GM 1.7D (ISUZU) / Synchronous Drive / Tensioner Info.

GATES REFERENCE:	5563XS & related kits.	
MAKE:	CHEVROLET / OPEL / VAUXHALL.	
MODEL:	Astra, Combo, Corsa, Cruze, Meriva, Mokka, Trax, Vita, Zafira.	
MOTOR:	1.7CDTI, 1.7D, 1.7DI, 1.7DTI.	
MOTOR CODE:	A17DT, A17DTC, A17DTE, A17DTF, A17DTJ, A17DTL, A17DTR, A17DTS, Y17DT, Y17DTL, Z17DT, Z17DTH, Z17DTJ, Z17DTR.

This Technical Bulletin replaces Technical Bulletin N° 009.

Fig. 3

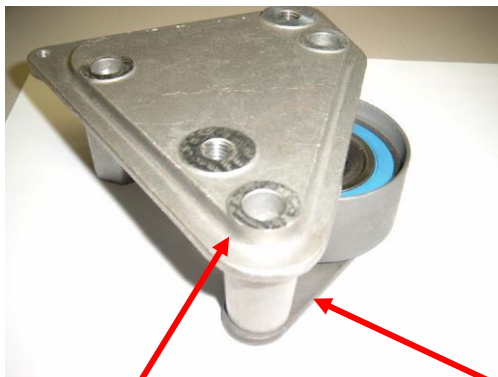
As the initial tensioner base plate was fitted under a leg of the engine support bracket (Fig. 3), K015563XS can only be used from engine nr 328704 on.

Fig. 4

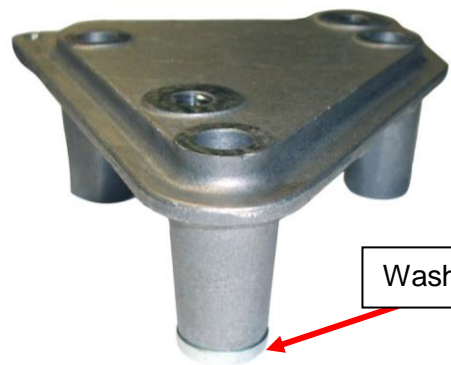
K025563XS is supplied with a washer to compensate the lost thickness of the base plate under the shorter leg of the early engine support bracket as in Fig. 4, and contains a stud which is needed to hook the new tensioner spring on (Fig. 5). This K02 can always be used: up to engine nr 328703, using the washer and the stud; and from engine nr 328704 without the washer and the stud.

Fig. 5

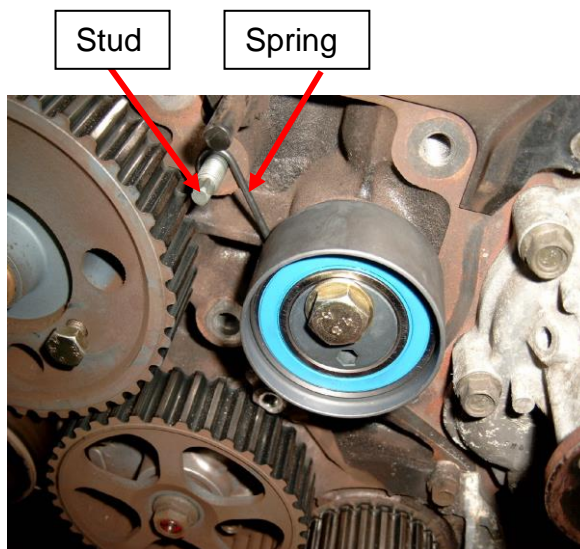
- 1) Remove the used tensioner, spring, idler and belt.
- 2) Install the new idler and bolt.
- 3) Insert and torque (18.6 Nm) the stud at the right hand side of the injection pump pulley (Fig. 5).

Fig. 6

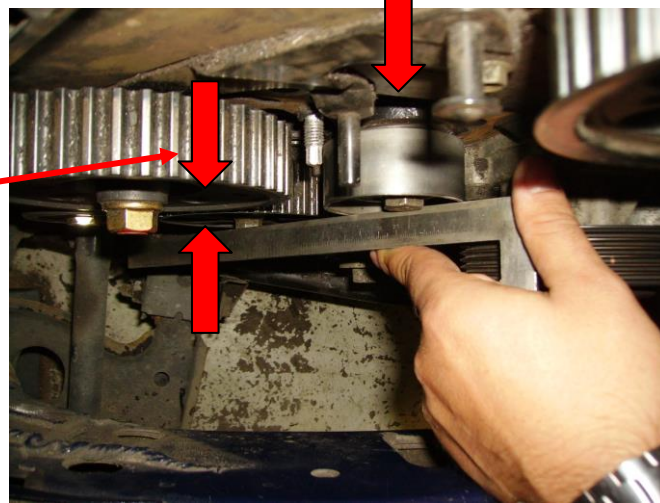
- 4) Install the new coil spring tensioner (spring over stud, bolt hand tight); make sure tensioner is sitting perfectly against engine block. If not, the spring could end up between the tensioner and the engine block, creating a serious tensioner misalignment (see Fig. 6).
- 5) Rotate the tensioner anticlockwise (Allen key) till the Allen key hole is in +/- 5 o'clock position.
- 6) Tighten the bolt.

Spring trapped behind tensioner

Serious misalignment

Fig. 7

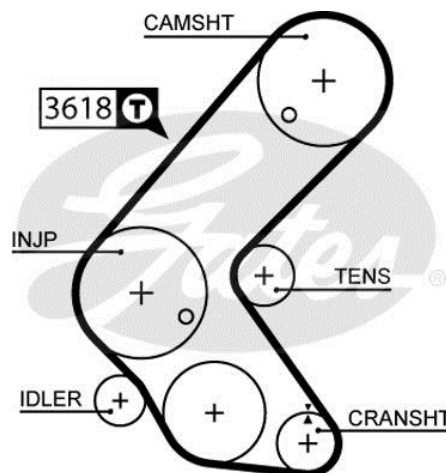
** After completing step 10 of the installation in procedure A), or step 9 in procedure B), it is highly recommended to check the tension in span **T**, (see drive system layout below - Fig. 7) using Gates Sonic Tension Tester STT-1.

Enter code 3618 in the STT-1 (ensure chip version 006 is installed) then measure in the normal way. If the tension is too high then the tensioner should be completely released and tensioning procedure repeated until the green light is obtained.

If the tension is too low then it will be necessary to assist the tensioner spring with the Allen key; until the green light is obtained.
